CE-05-52  
May 9, 2005

# SPECIAL AIRWORTHINESS INFORMATION BULLETIN

This Special Airworthiness Information Bulletin (SAIB) alerts you, owners and operators of **Apex Aircraft model CAP 10 B airplanes**, that the Direction Generale De L'Aviation Civile (DGAC), airworthiness authority for France, issued French Airworthiness Directive (AD) No. F-2004-144 dated August 28, 2004. This AD affects serial numbers (SN) 300 through 310, SN 312 & 313, and all SNs up to and including 299 that are changed under "CAP 10C wing" modification 000302.

APEX Aircraft Bureau de Navigabilité 1, route de Troyes 21121 DAROIS - France Tél +33 380 35 65 10 Fax +33 380 35 65 15 www.apex-aircraft.com	<h1>SERVICE BULLETIN</h1> <p>No. <b>031101</b></p>
<b>CAP10B - Flight controls - Aileron bellcrank pivot bolt replacement</b>	
Supersedes : N/A

Aileron bellcrank

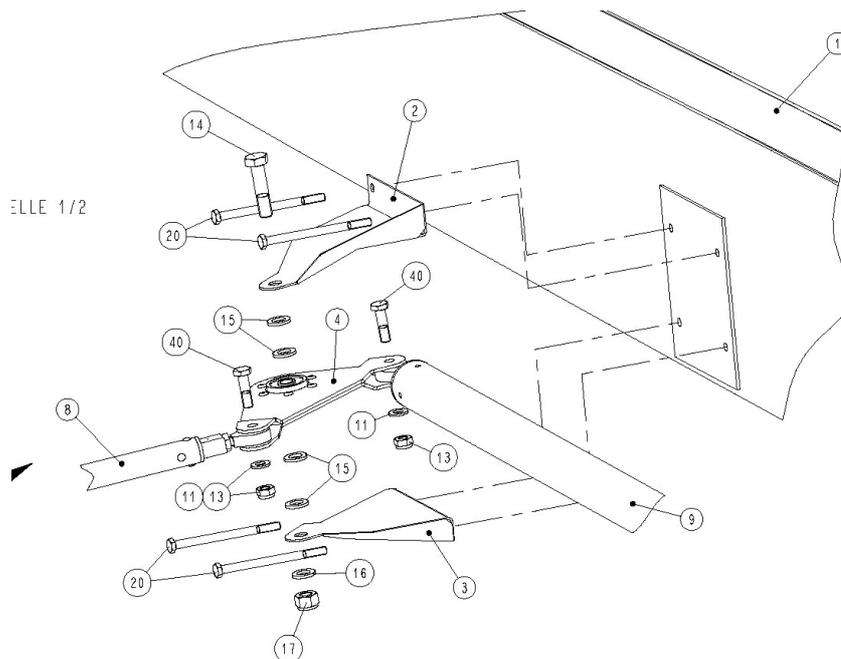
The aileron bellcrank (item 4) is fixed on 2 brackets by means of an AN5-12A bolt (item 14). Two washers (AN960-516) are installed on each side of the aileron bellcrank (item 15).

- Replace the AN5-12A bolt (item 14) with an AN5-13A bolt (the latter being longer).
- Replace each set of two AN960-516 washers (item 15) with one spacer 2714-0311003 (Apex part number).
- Also replace the washer (item 16) with a spacer 2714-0311003.
- Replace the bolt and washers on left hand and right hand wings.
